HISTORIC AND DESIGN REVIEW COMMISSION March 21, 2018

HDRC CASE NO: 2018-097 808 E CARSON **ADDRESS:** NCB 1266 BLK 2 LOT 2 **LEGAL DESCRIPTION: ZONING:** R-6, H **CITY COUNCIL DIST.:** 2 **DISTRICT:** Government Hill Historic District **APPLICANT:** Pegy Brimhall **OWNER:** 808 E Carson, LLC Construction of two, two story residential structures **TYPE OF WORK:** February 22, 2018 **APPLICATION RECEIVED:** April 23, 2018 **60-DAY REVIEW:**

The applicant is requesting conceptual approval to construct two, two story, multi-family residential structures on the vacant lot at 808 E Carson.

Sheet Contents: Building Sections

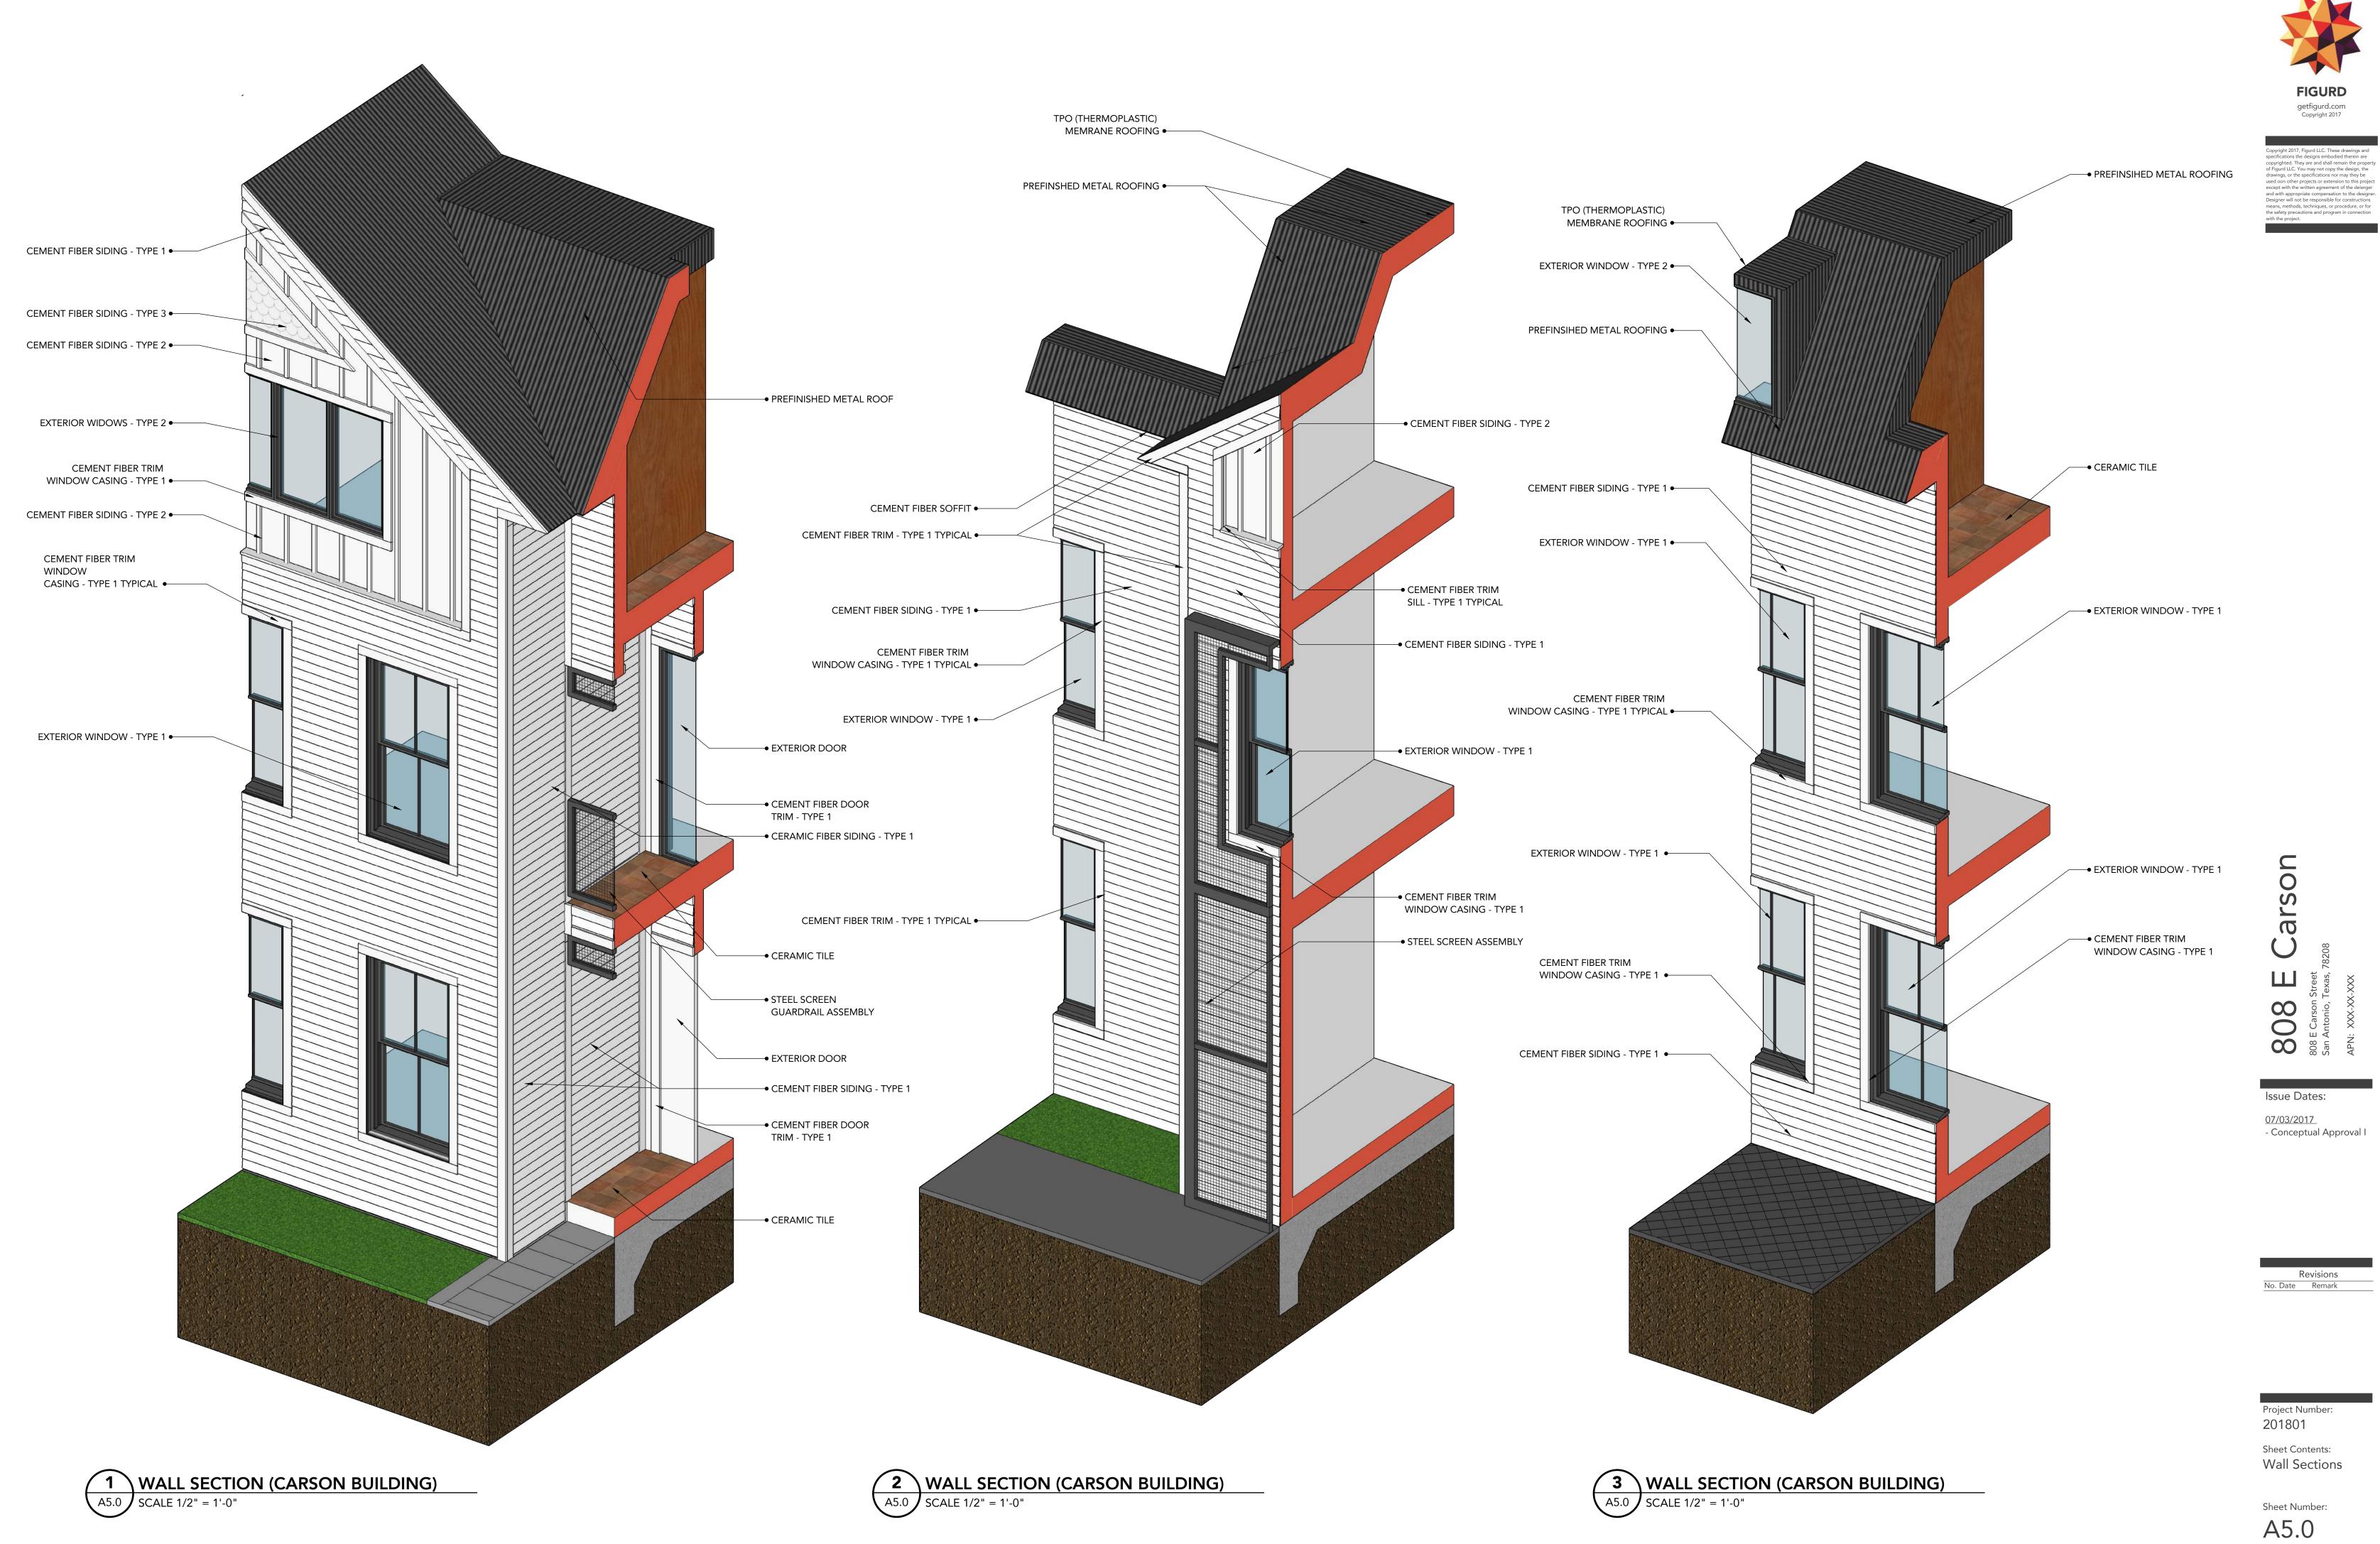
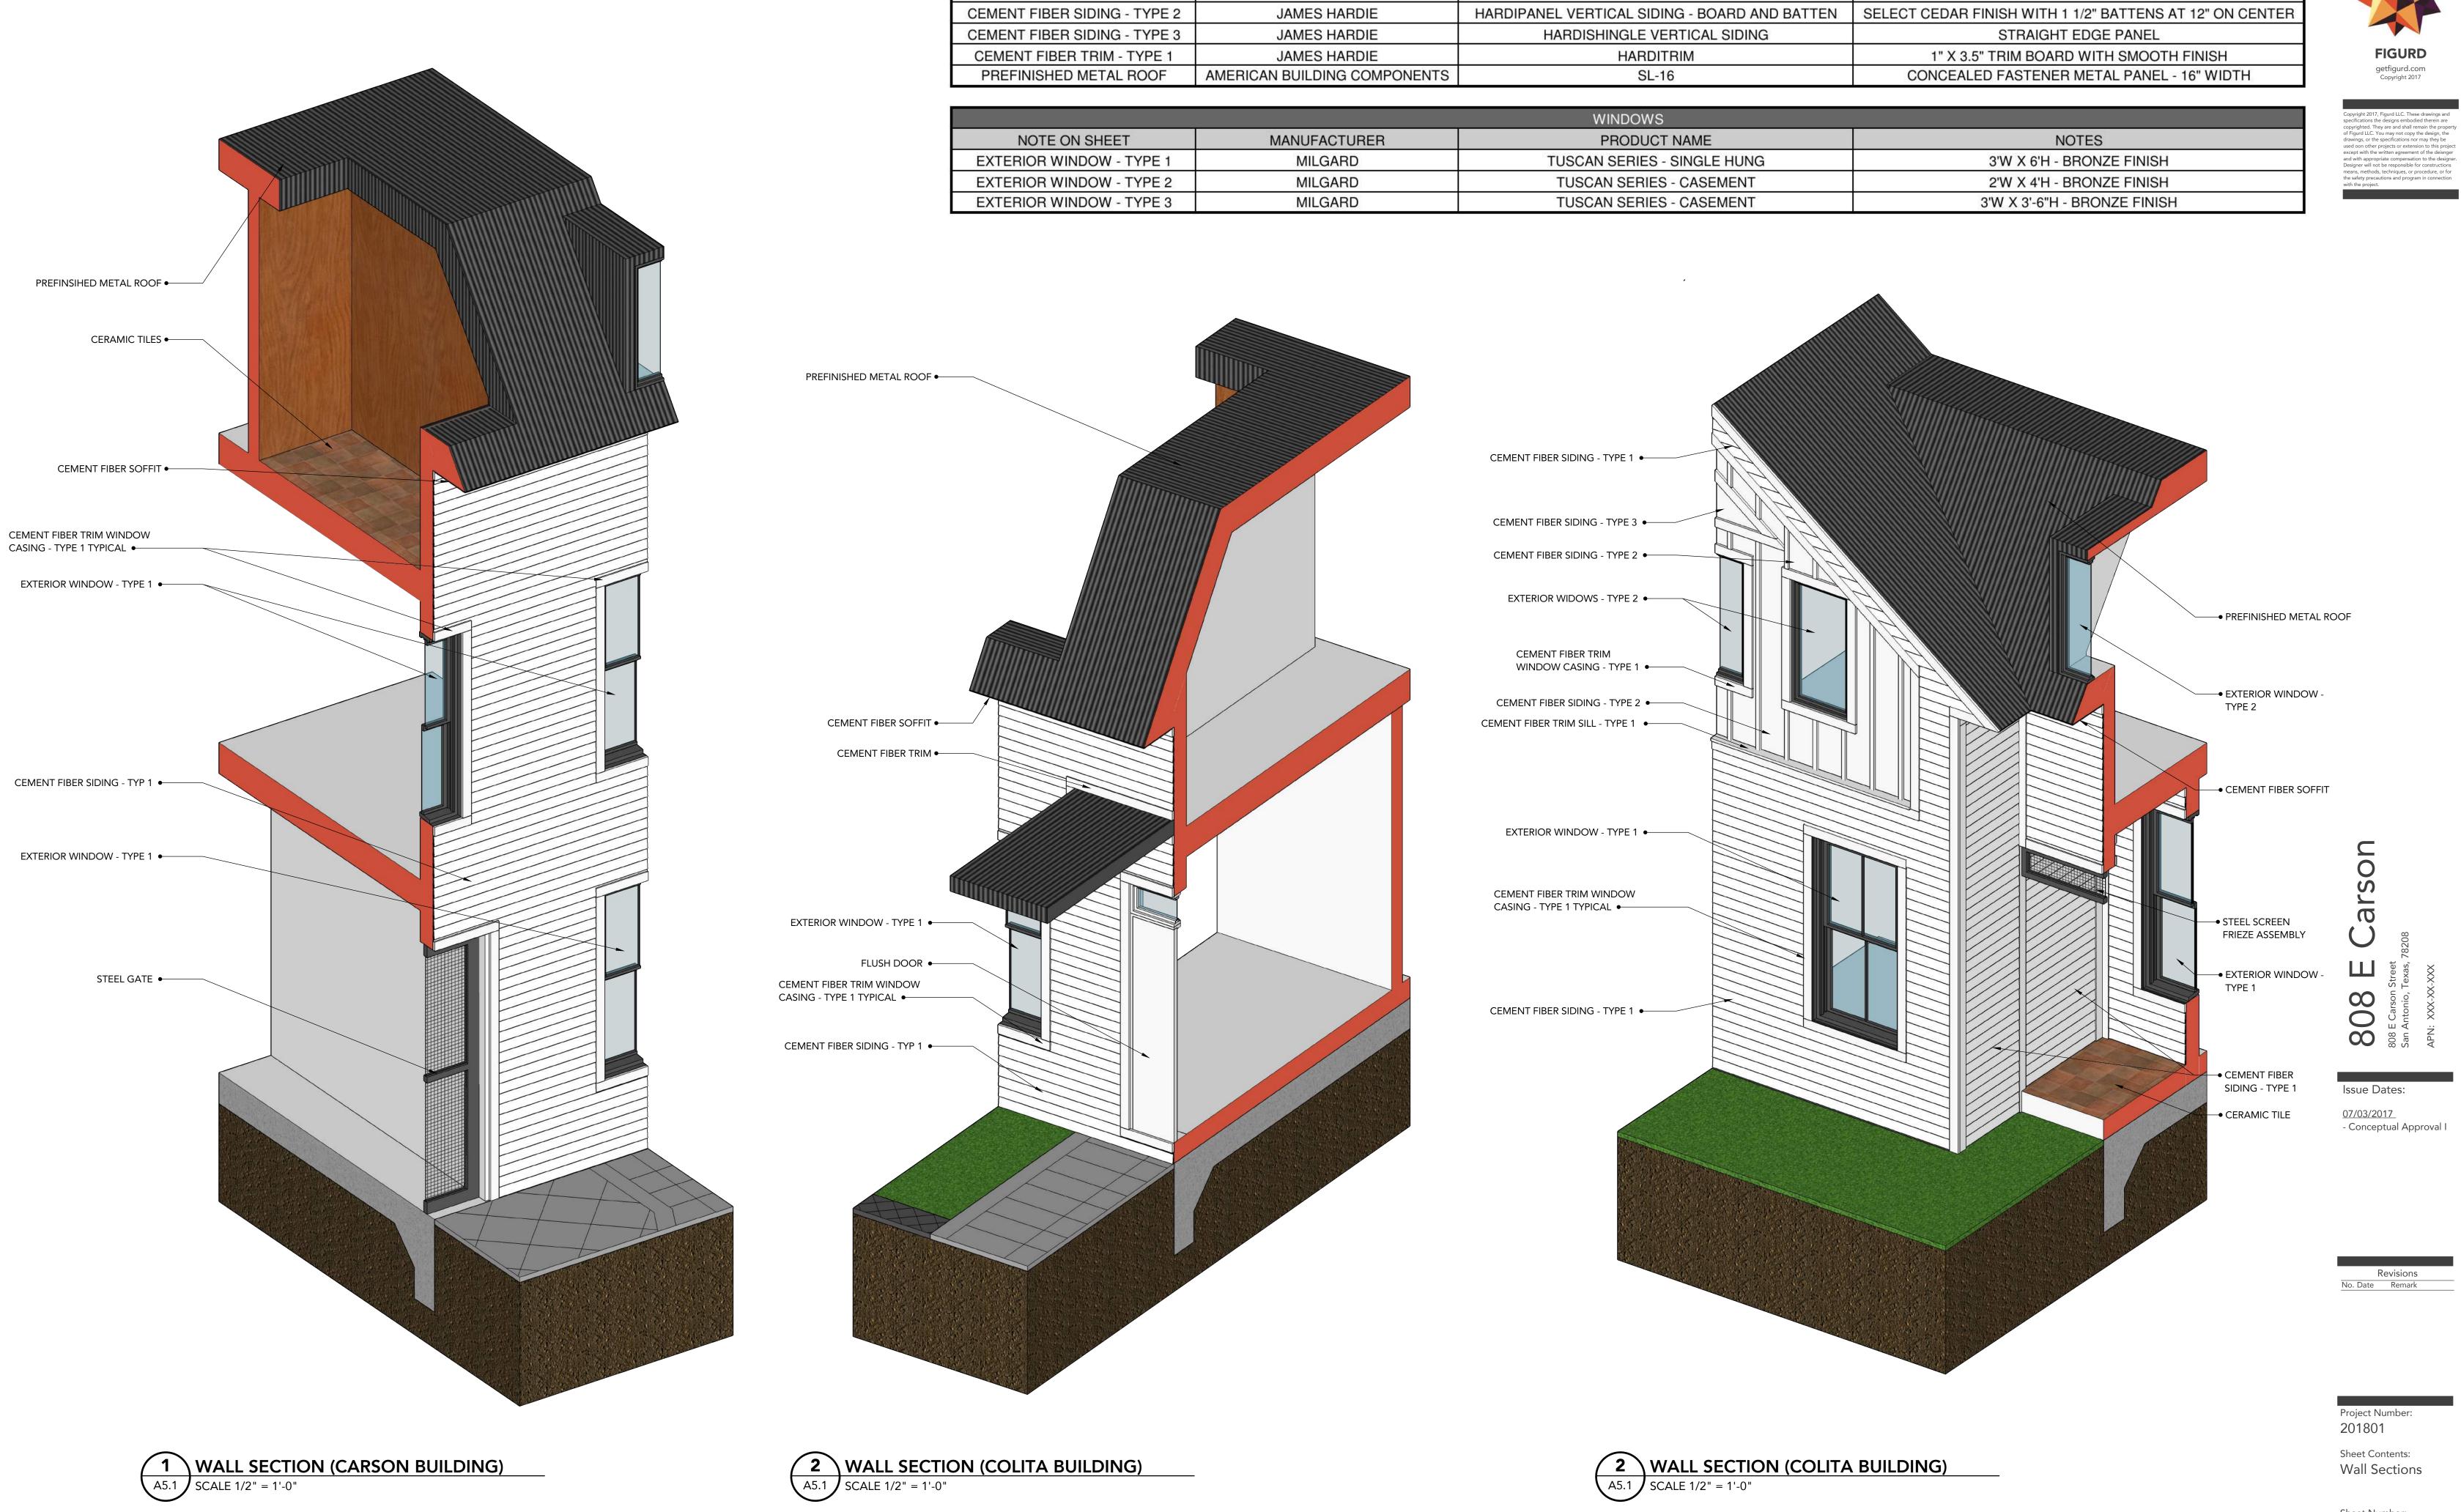
- f. SCALE & MASS (E Carson) Per the Guidelines for New Construction 2.A.i., a height and massing similar to historic structures in the vicinity of the proposed new construction should be used. In residential districts, the height and scale of new construction should not exceed that of the majority of historic buildings by more than one-story. This block of E Carson features seven residential structures, three of which feature two stories in height. While there are examples of historic structures nearby that feature multiple stories in height, the proposed new construction features a total height of 32' 4" (E Carson structure). Staff finds the proposed height of the structure to address E Carson inconsistent with the Guidelines. Additionally, the proposed massing features solid wall planes at locations where historic structures feature voids for porches.

- g. SCALE & MASS (Colita) The applicant has reduced the proposed massing of the rear unit that is to address Colita to feature an overall height of 22' 4". The proposed rear structure's massing is subordinate to that of the proposed primary structure and generally consistent with the Guidelines.

- h. FOUNDATION & FLOOR HEIGHTS According to the Guidelines for New Construction 2.A.iii., foundation and floor height should be aligned within one (1) foot of neighboring structure's foundation and floor heights. The applicant has not provided specifics for foundation heights at this time. The applicant is responsible for complying with the Guidelines.

- i. That porches or porch like elements should be incorporated as noted in finding e.
- ii. That the proposed roof height should be lowered as noted in findings f and j.
- iii. That porches should be included to be recessed behind protruding bays as noted in finding n.
- iv. That the applicant continue to develop materials with the specifications noted in finding m.
